CERTIFICATE OF THE SECRETARY OF ENERGY AND ENVIRONMENTAL AFFAIRS ON
THE DRAFT ENVIRONMENTAL IMPACT REPORT

PROJECT NAME : Reserved Channel Master Plan Development
PROJECT MUNICIPALITY : Boston
PROJECT WATERSHED : Boston Harbor
EEA NUMBER : 16802
PROJECT PROPONENT : Oxford Properties Group and Pappas Enterprises
DATE NOTICED IN MONITOR : November 26, 2025

1.1a — RCD DEIR (5/28/2026), p 602

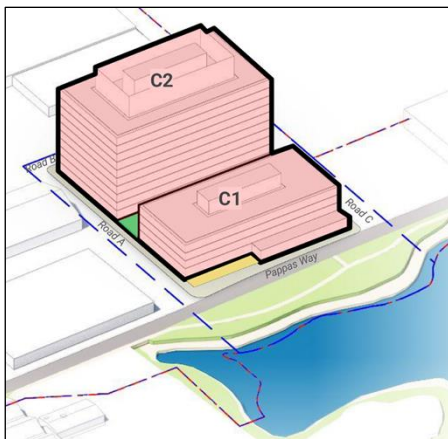
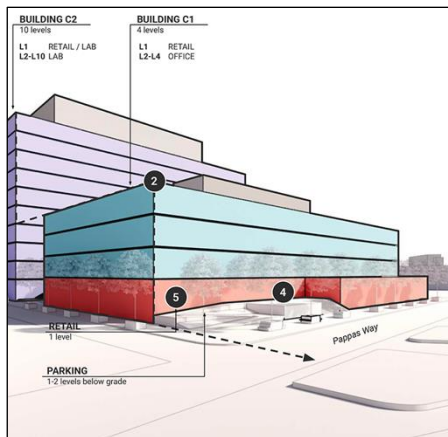
Unlike the Proponent's proposal for the Reserved Channel (Fig. 1.1a), prominent projects located along Boston's waterfront, from Fort Point Channel to Seaport, omits a road between the building and their adjacent waterfront (Figs.1.1c-1.1f) that help to promote:

1.3a — Based Drawing: RCD DEIR (5/28/2026), p 207

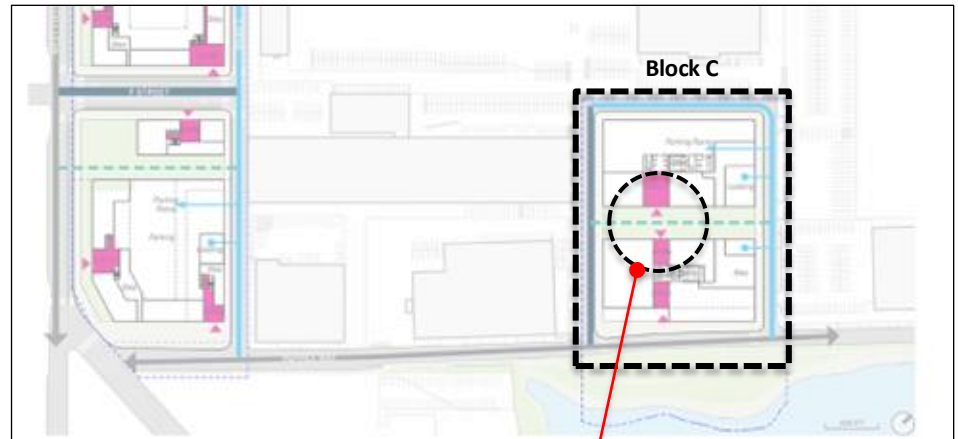
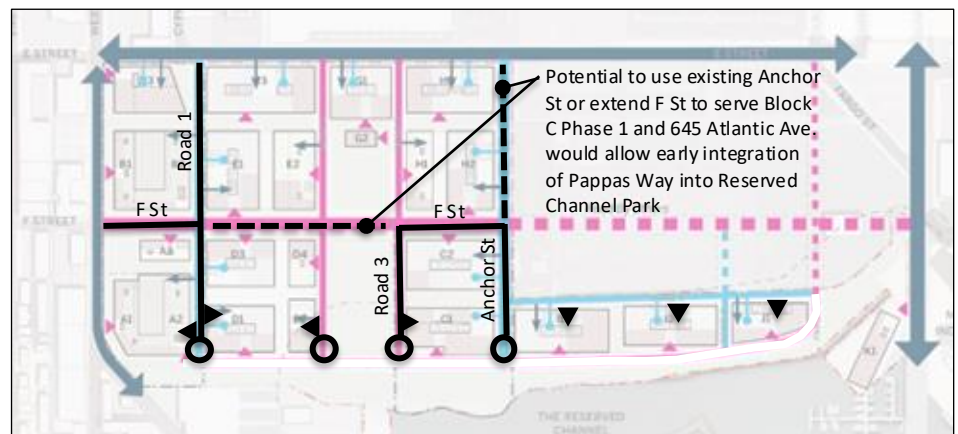
The DEIR illustrates that all Phase 1 and full-buildout buildings would have at least two to three side streets (Fig. 1.3a), and/or located adjacent to attractive secondary open spaces shared with another building (Fig. 1.3b), similar to, and demonstrated at, 5 and 15 Necco St. that face Ft. Pt. Channel (Fig. 1.3c).

As illustrated previously in Figs. 1.2a-1.2d, curbside drop-off/pickup may be accommodated along a side street. When necessary, the drop-off/pickup lane can terminate with a cul-de-sac (Fig. 1.2c) without looping between the building and waterfront. Similar or identical entrance orientations and street cul-de-sac solutions can be implemented for Blocks A, C, D, I, and J, and associated east-west side streets (Fig. 1.3d), thus eliminating the need to maintain Pappas Way as a roadway.

2.1a — West 1st St Existing (left) & Proposed (right) Sections, RCD DEIR (5/28/2026), p 191

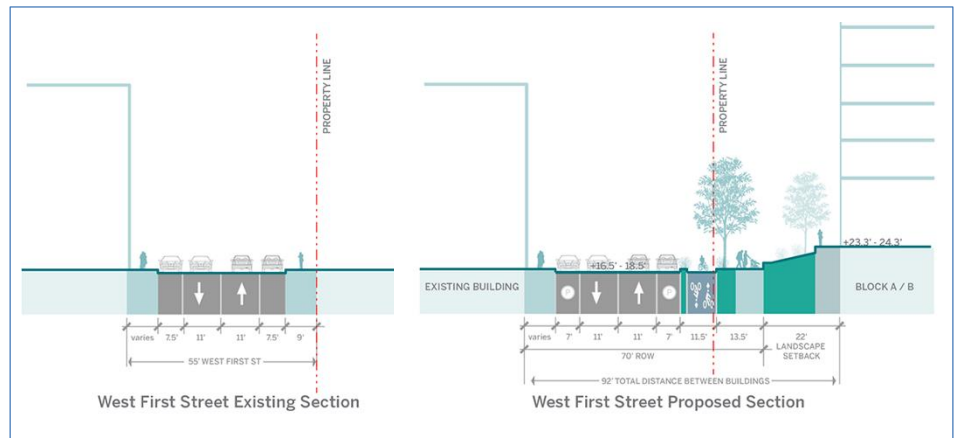
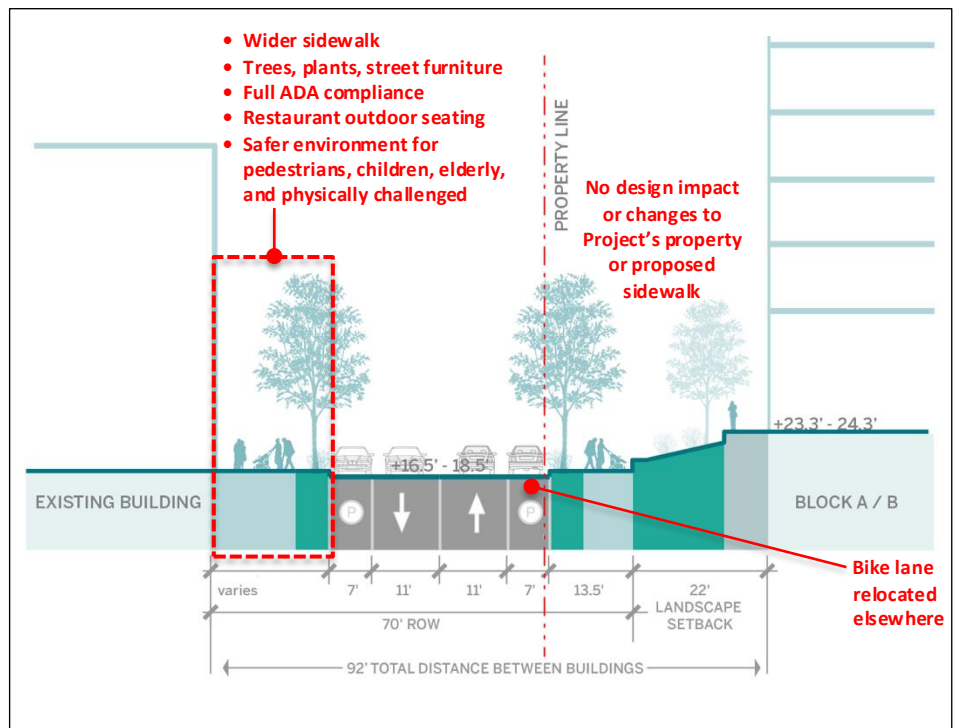
Options to expand the south sidewalk is challenging since new residences have been completed. Limited choices include eliminating a lane used for parking, vehicles, or the bicycle lane proposed in the DEIR. Since the first two lane types are in place and heavily used and needed, it would appear that one solution is to forego installing the proposed bicycle lane and relocating the extra space to the south side of West 1st St. while shifting parking and vehicular lanes to the north side (Fig. 2.1b). Alternatively, a bicycle-sharing sidewalk on the south side may offer a flexible acceptable option as implemented elsewhere (Figs. 2.1c-2.1f).

2.1b — Alternative Section for West 1st St, Base Drawing: RCD DEIR (5/28/2026), p 191 [edited]

3.0a — Alternative RCD master plan. Based Drawings: RCD DEIR (5/28/2026), p 32 & 34 [edited]

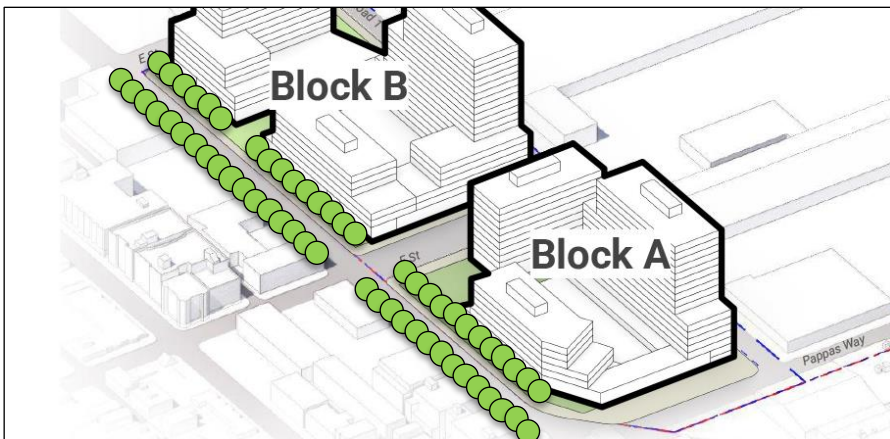
Excellent examples around the world demonstrate the attractiveness of waterfront parks without intrusions by roadways between buildings and their adjoining waterfronts (Figs. 1.0e-1.0j). The advantages are numerous, including:

3.0b — A verdant greenway on Reserved Channel. Based Dwg.: RCD DEIR (5/28/2026), p 587 [edited]

3.0c — A tree-lined boulevard for West 1st Street. Based Drawing: DEIR (5/28/2026), p 587 [edited]

Figure 3. DHW energy consumption for bins of ten years from 1900 to 2010 for NYC multi-family buildings over 25,000 ft². Each label on the x-axis is the start of the decade the bin represents.

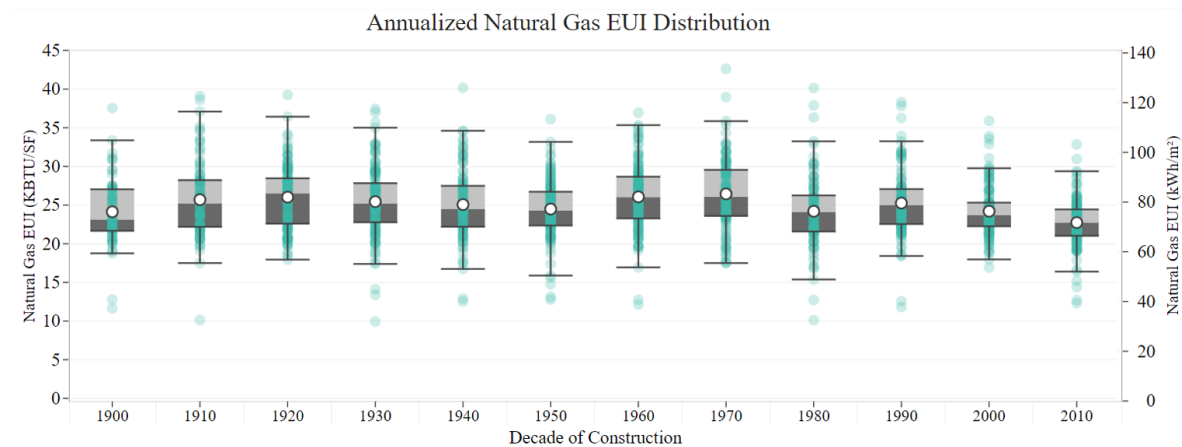
demand is about **20 kBtu/sf-yr**. (Calculated as 25 kBtu/sf-yr x 80% typical efficiency of fossil fuel hot water production.)

Based on these measured results, it's recommended that the proponent use domestic hot water demand of **20 kBtu/sf-yr** for water heating evaluations.
